# Bay Colony Group, Inc.

May 17, 2023

## **RE: 31 WATER STREET FOXBOROUGH, MA (SE157-0610)**

I am submitting herewith in accordance with Condition #30 of Attachment A to the Order of Conditions a revised site plan for the construction of a single-family home at 31 Water Street. The modifications to the plan are due to the owner finalizing the floor plans for the home and involve the new home footprint and a revised driveway configuration.

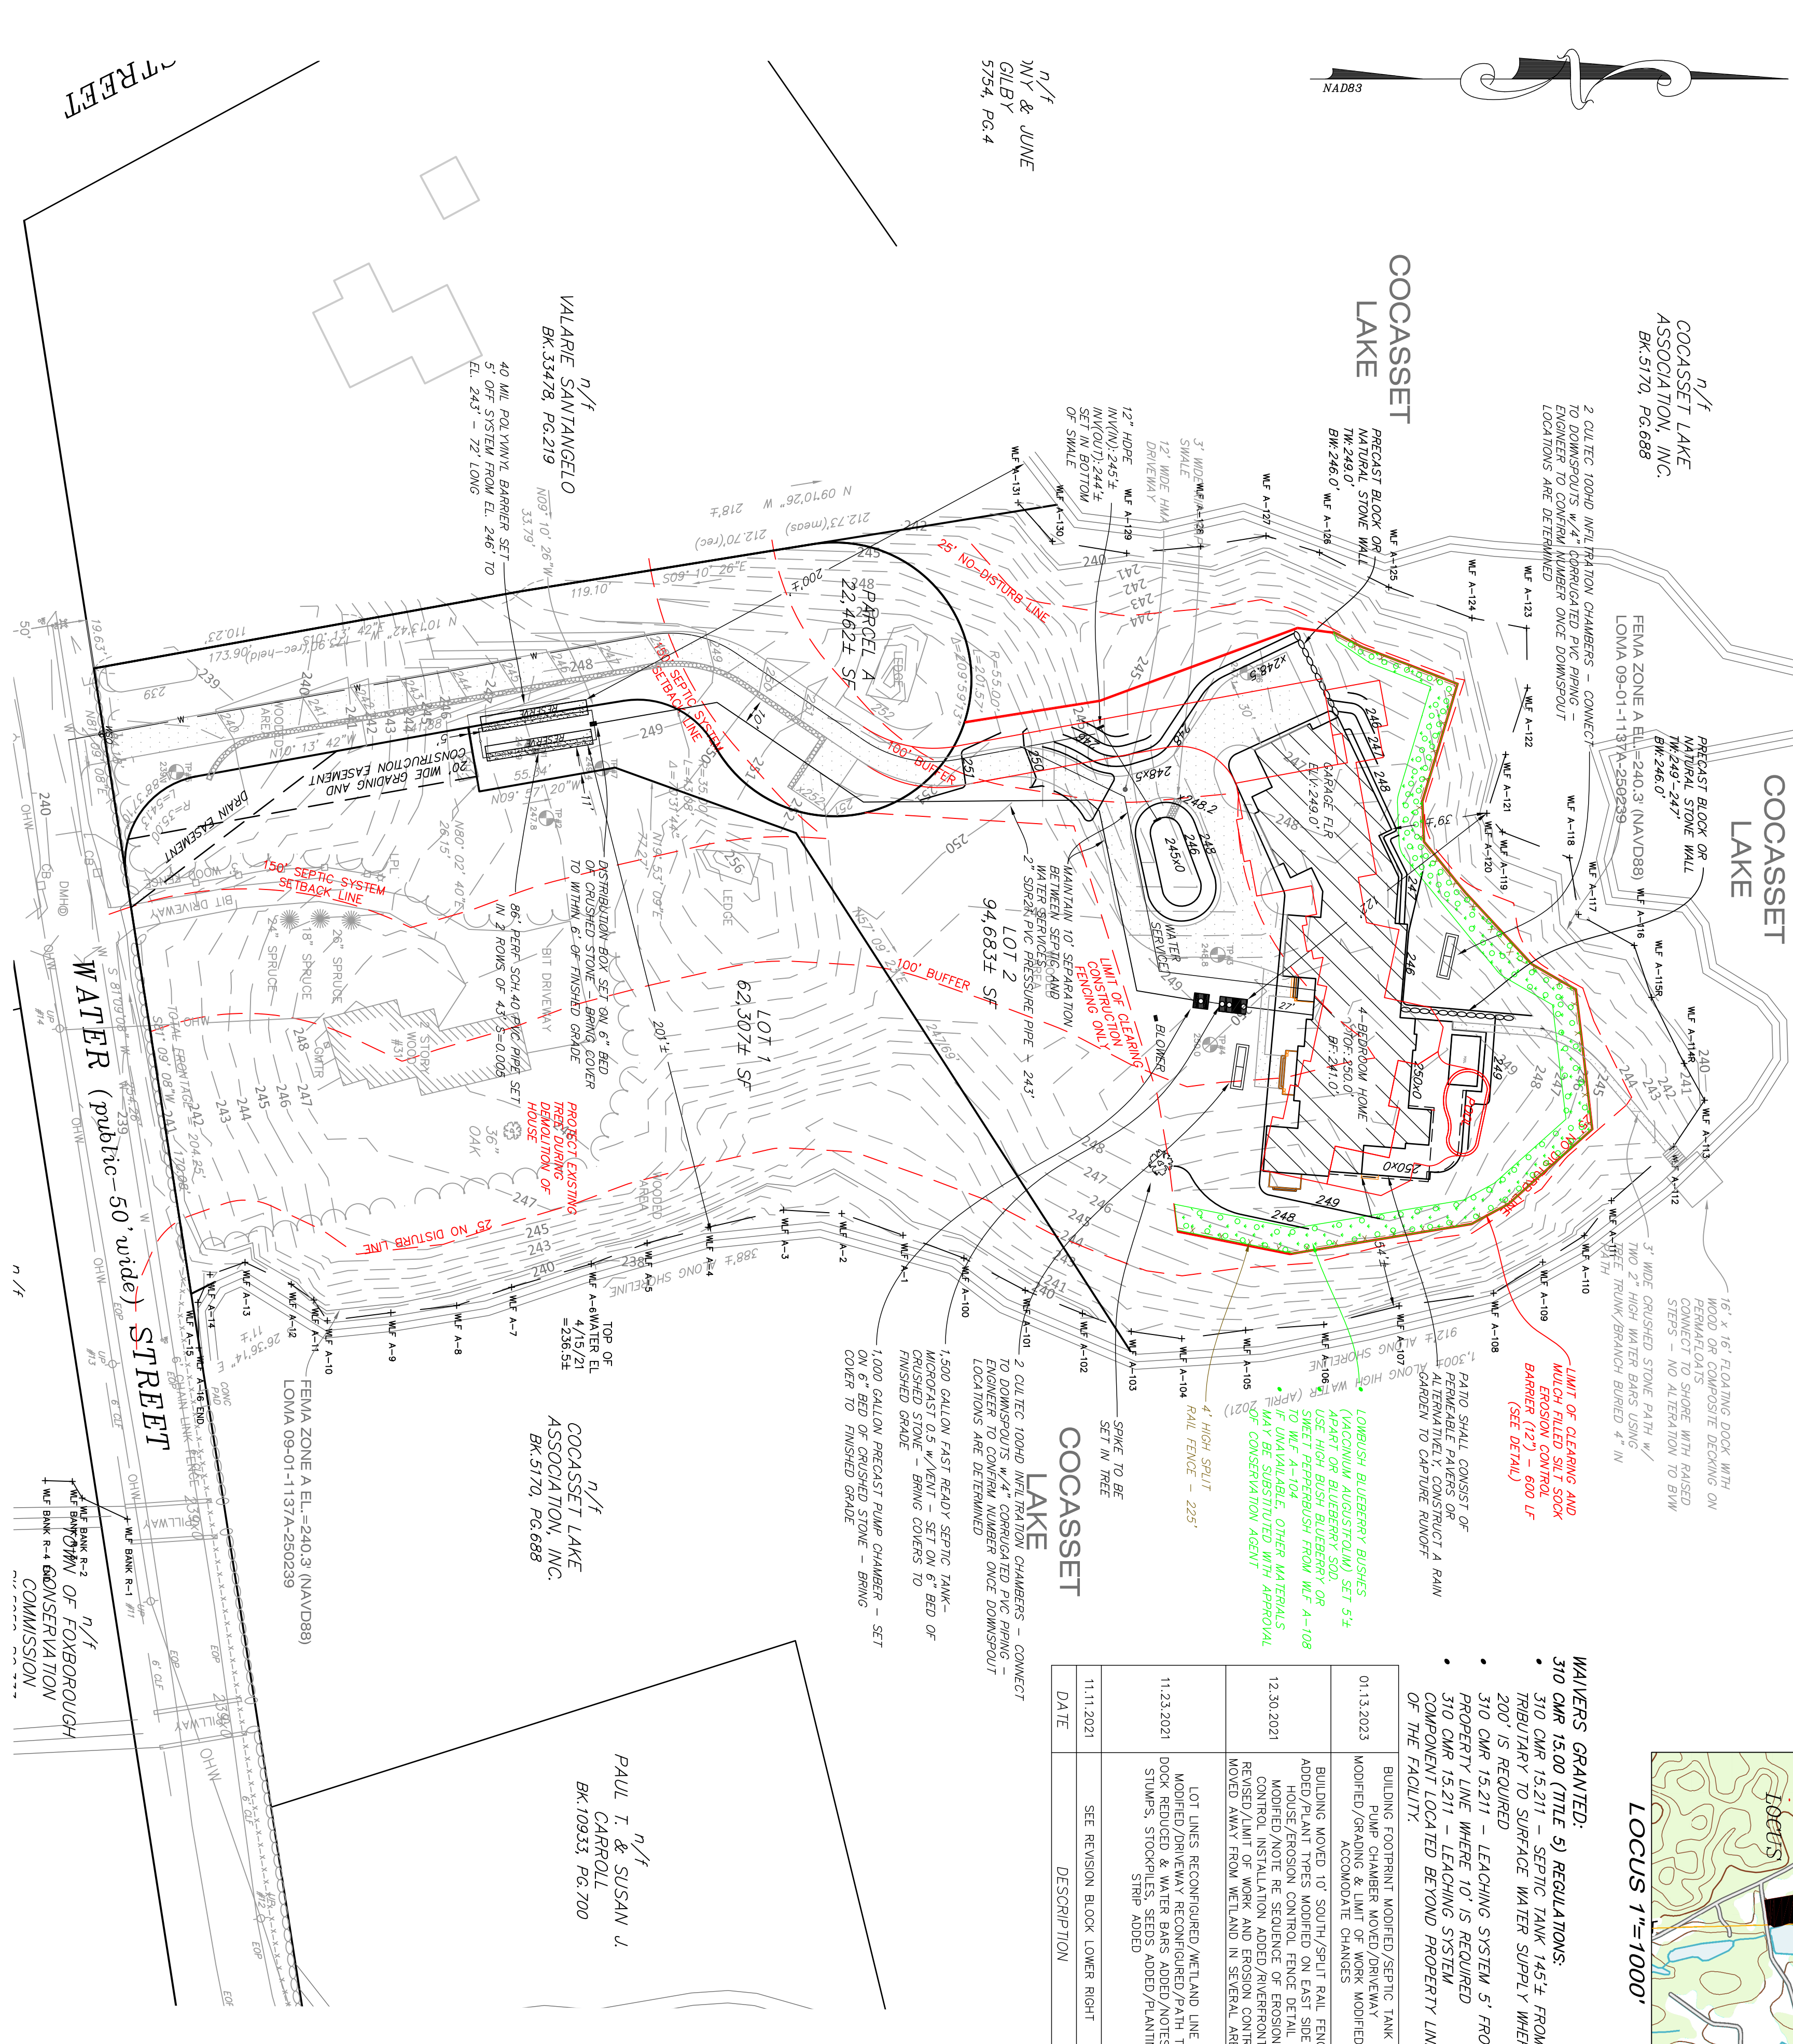
I have also included a separate plan that shows in red the house, patio, pool and driveway as approved by the Commission in February, 2022. The house size has changed from 7,225 sf to 7,780 sf with the major change being the elimination of the separate bedroom that was nw of the garage and the "nook" in the center of the house near the pool. The expansion of the footprint has largely taken place in the front yard. The pool size has been decreased from 492 sf to 233 sf and the patio size has decreased from 1,364 sf to 1,164 sf. The driveway area within the buffer zone has decreased from 3,450 sf to 2,718 sf. The total impervious area in the buffer zone has decreased from 12,174 sf to 11,662 sf.

At its closest point the revised house location is 56' from the BVW, which is less than the approved design which was 36' at the nw corner of the house. The pool is now 69' from the BVW which is less than the approved design which was 52'. The location of the septic system and roof recharge systems have not changed and there is 717 sf less clearing to the west side of the driveway where the driveway now curves in toward the center of the lot where it previously came straight to the garage. One area where the driveway is about 2' closer (44' vs 42') to the BVW is where the driveway meets the garage. The limit of work is about 4' closer and 55 sf larger than the original design.
